ALL COMMENTS ARE
LOCATED ON COVER
SHEET, E5A, AND E5B

Project:	WEBSTER UNIVERSITY INTERDISCIPLINARY SCIENCE BUILDING				
Customer:	PARIC CORPORATION				
Owner:	WEBSTER UNIVERSITY				
Location:	WEBSTER GUVES, MO 63119				
Dwn:	TLI	Date:	06/10/2016	Ckd:	LJ
		Date:	06/20/2016		
Job No.	A16013	BAT:		DWG#:	E5A

PROJECT: 15051-Webster University Interdisciplinary Science Building

RE: Webster Seq 5 Steel

LEVEL 05 FLOOR FRAMING PLAN SEQ5
T.O.S. EL. +150'-2 3/4 (UNO)
REF: S0107

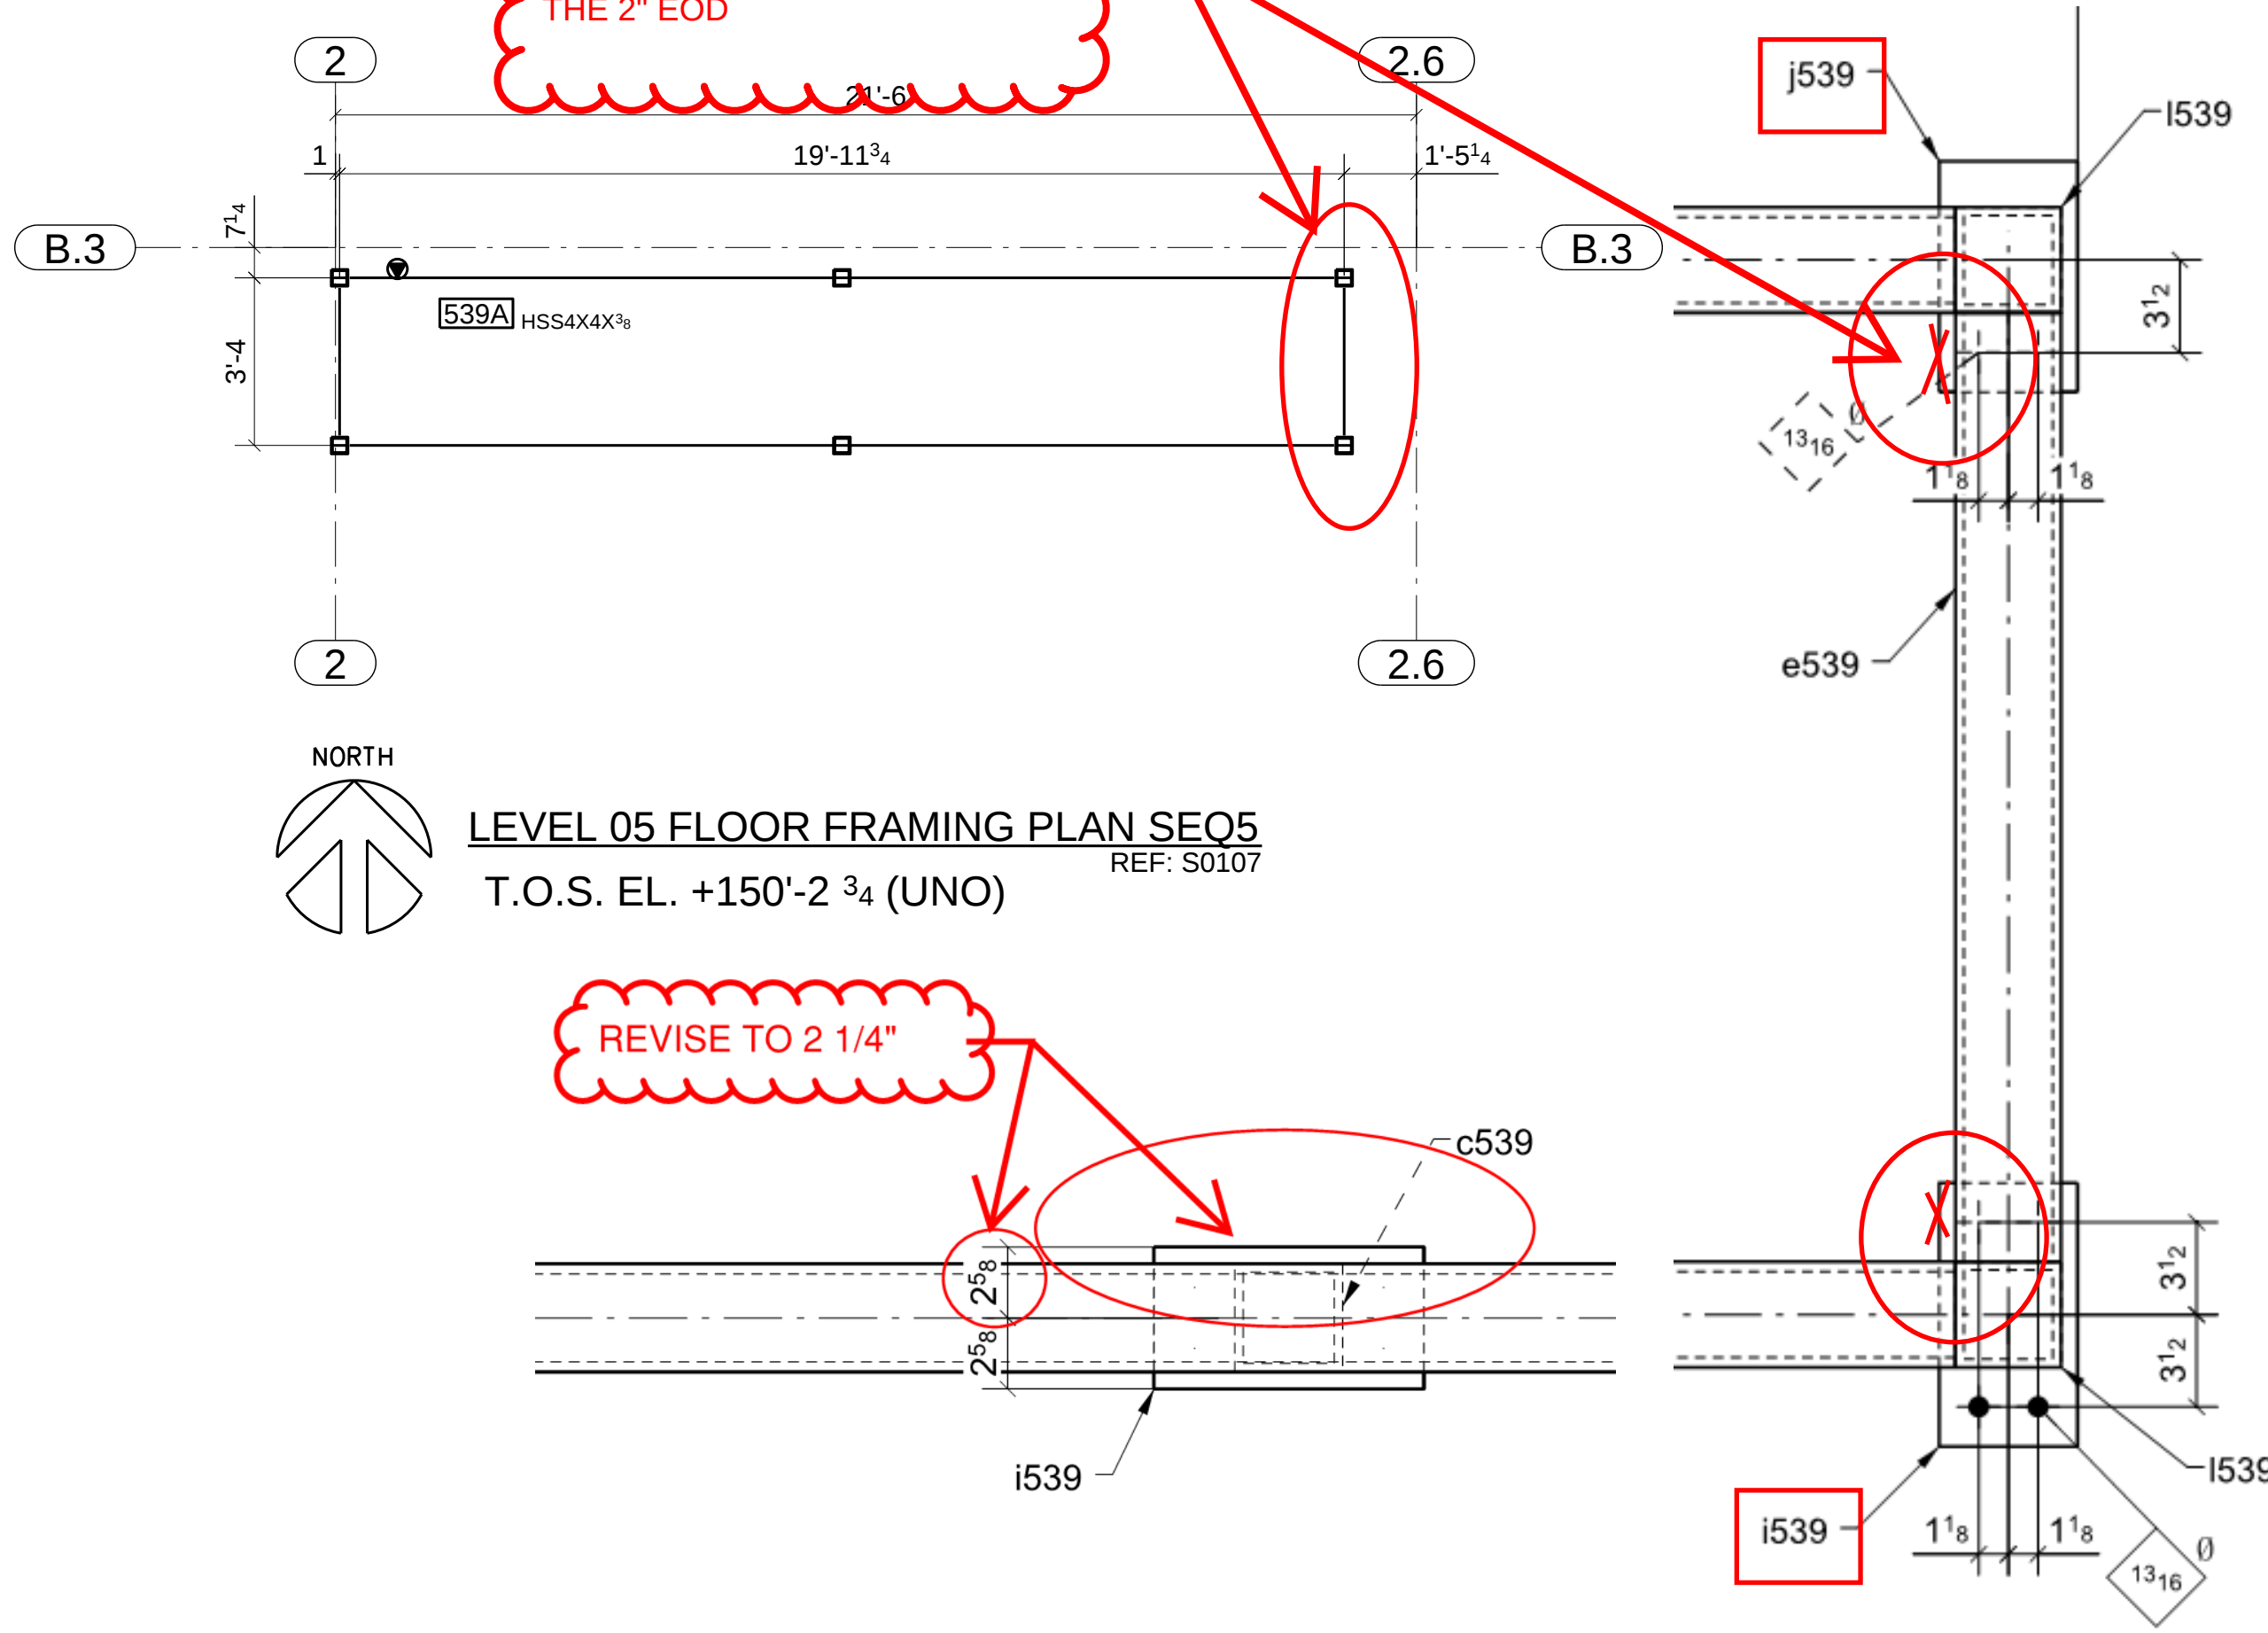
REVISE BASE PLATES (j539 & i539) TO LIMIT THE INTRUSION OF THE PLATE INTO THE INTERIOR SPACE BY 1/4" PAST THE 2" EOD

SECTION E5A ELEVATION ON LINE 5

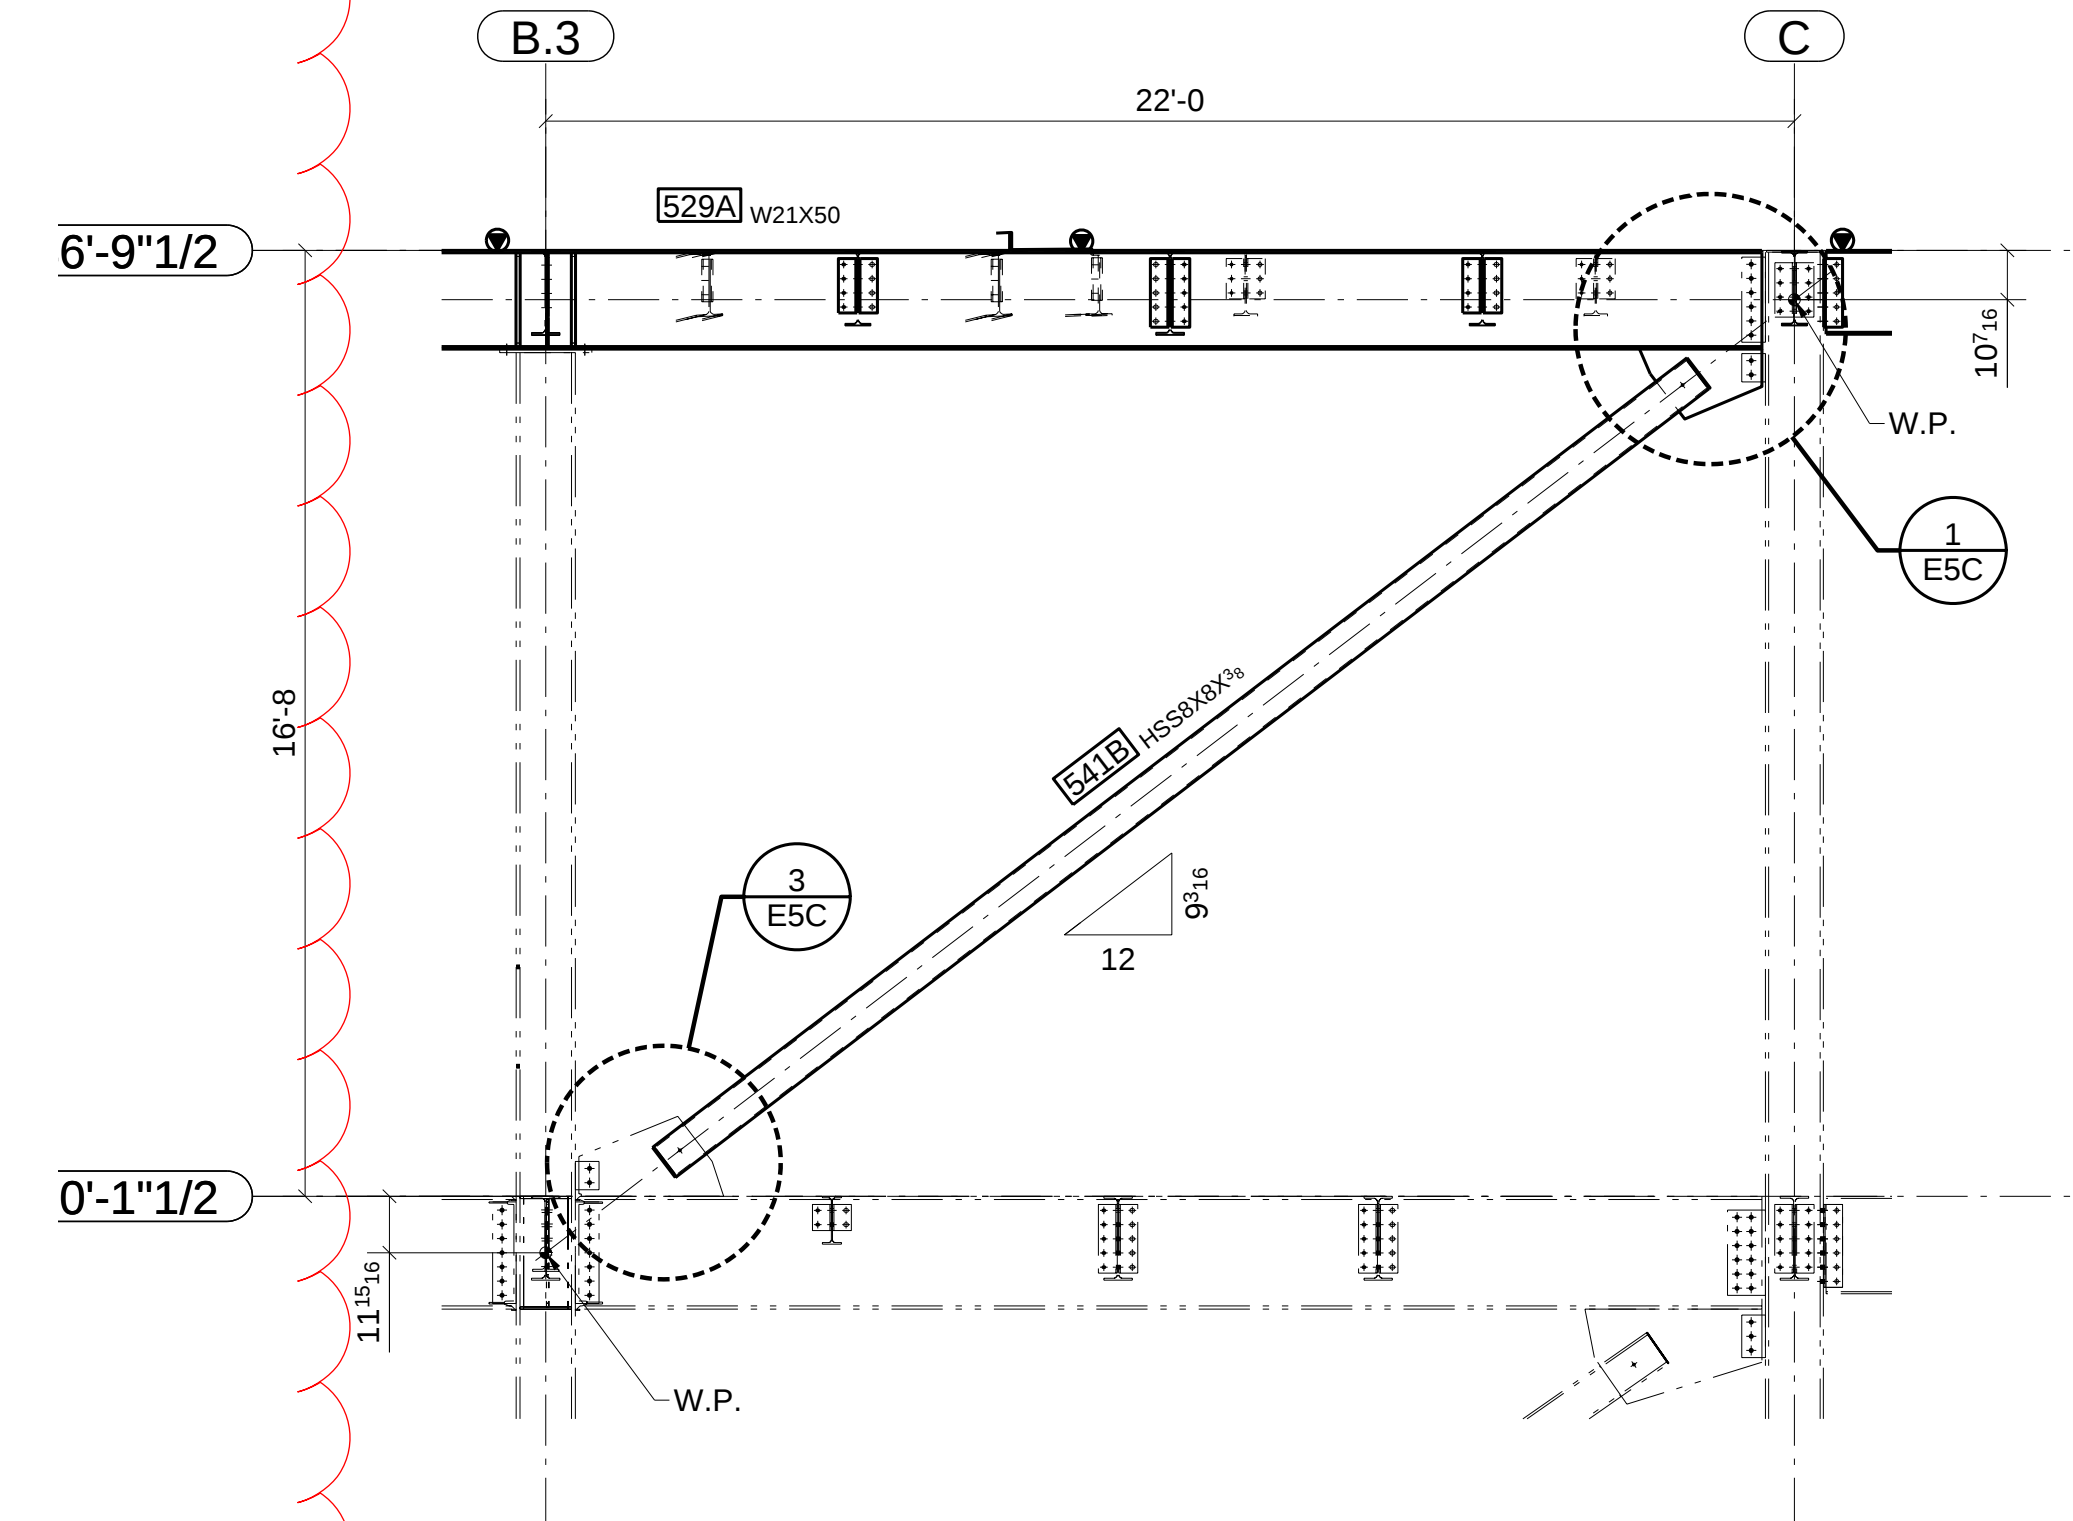
REVISE TO 2 1/4"
